Hearings Examiner Meeting Agenda Tuesday, February 01, 2022, 5:00 PM REMOTE PARTICIPATION

Vom Baur Fourplex

File No. CUP21-02

TO	Hearings Examiner	HEARING DATE	February 1, 2022
PROPOSAL	To construct an additional three units to an existing single-family residence, totaling four units.		
LOCATION	The site is located at 124 SE Everett St in the SE ¼ of Section 11, Township 1 North, Range 3 East, of the Willamette Meridian; and described as tax parcel 89235000.		
APPLICANT/ CONTACT	James Hall 640 NW 19 th Camas, WA 98607	OWNER	Cory Vom Baur 124 SE Everett St Camas, WA 98607
APPLICATION SUBMITTED	January 29, 2021 Resubmitted April 22, 2021 Resubmitted October 4, 2021	APPLICATION COMPLETE	October 15, 2021
PUBLIC NOTICES	<p>A Notice of Application was mailed to property owners within 300 feet of the site and published in the Post Record on October 21, 2021. Legal publication no. 612270.</p> <p>A Notice of Public Hearing was mailed to property owners within 300 feet of the site and published in the Post Record on January 6, 2022. Legal publication no. 638240.</p>

GRAPHIC A

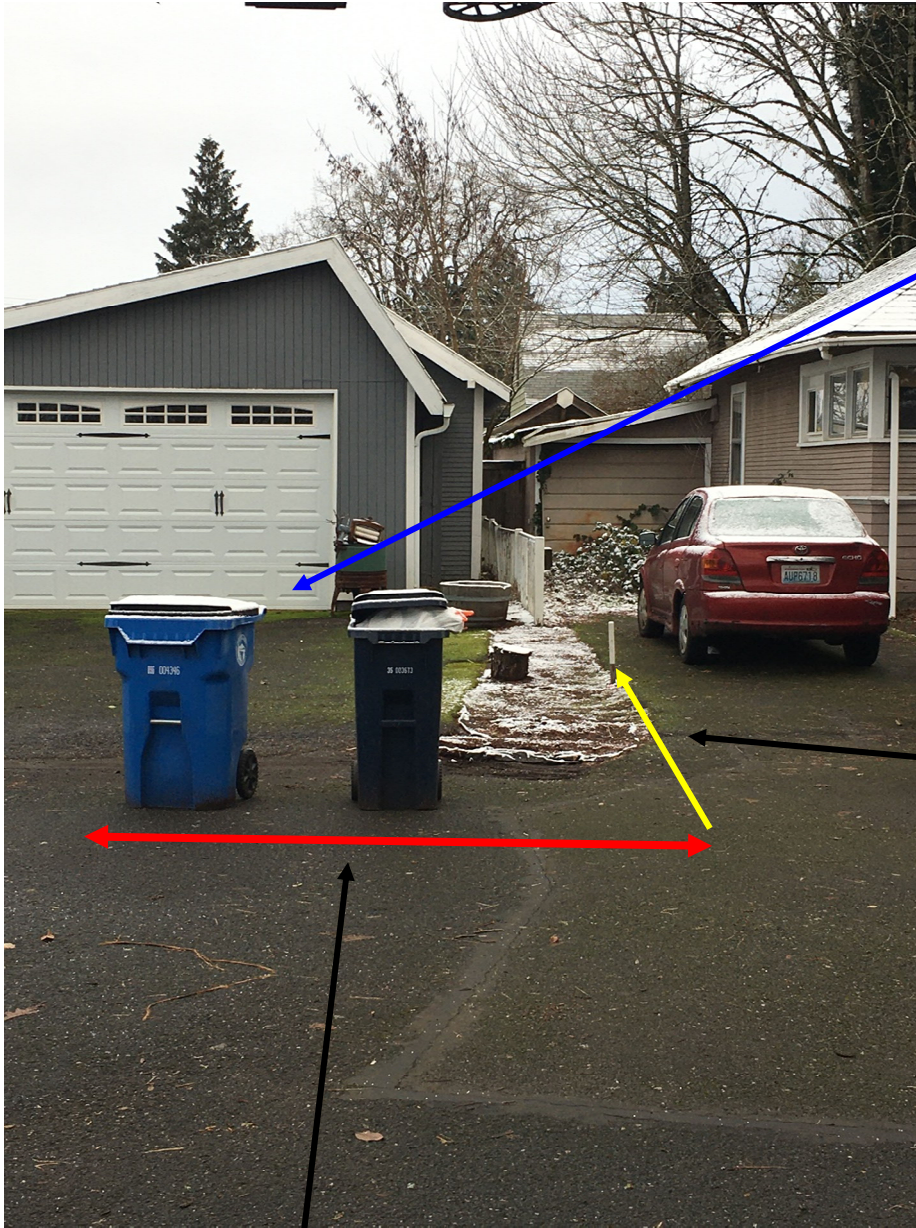
Two (2) Vom Baur waste containers placed in front of Milner property for weekly pickup so that the Vom Baur driveway is unobstructed.

The **blue line** depicts the very limited street frontage at the Vom Baur property, an area too limited for waste vehicles to access the Vom Baur's containers for pickup. **Side loading garbage trucks simply cannot access the Vom Baur's waste containers in front of the Vom Baur property (there just isn't room for the truck).**

GRAPHIC C

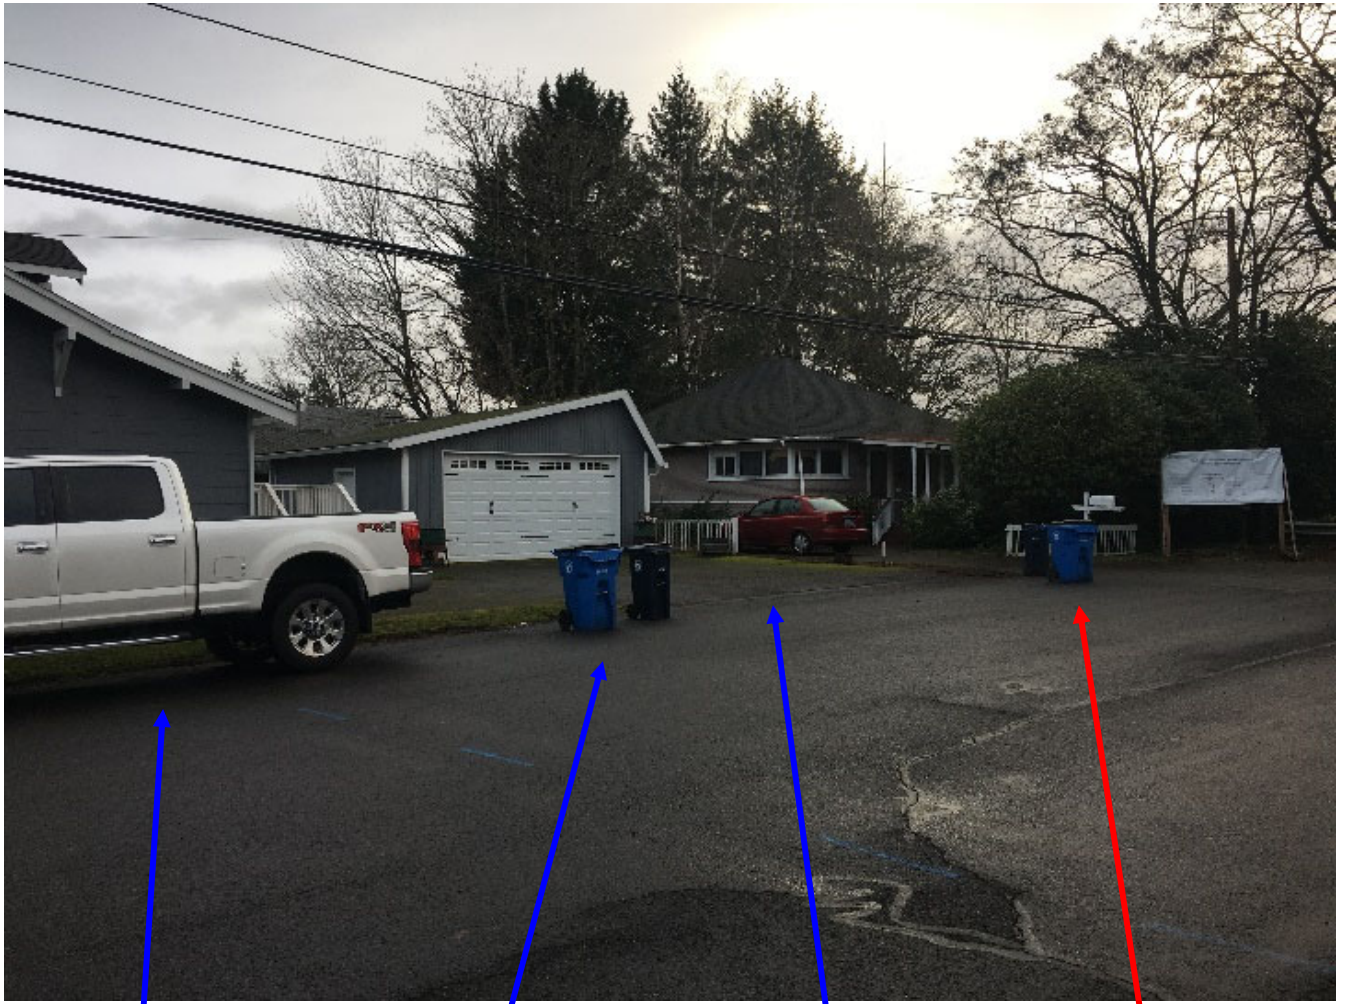
Garbage collection day, existing container placement
(2 Milner and 2 Vom Baur containers)

Milner vehicle street parking.
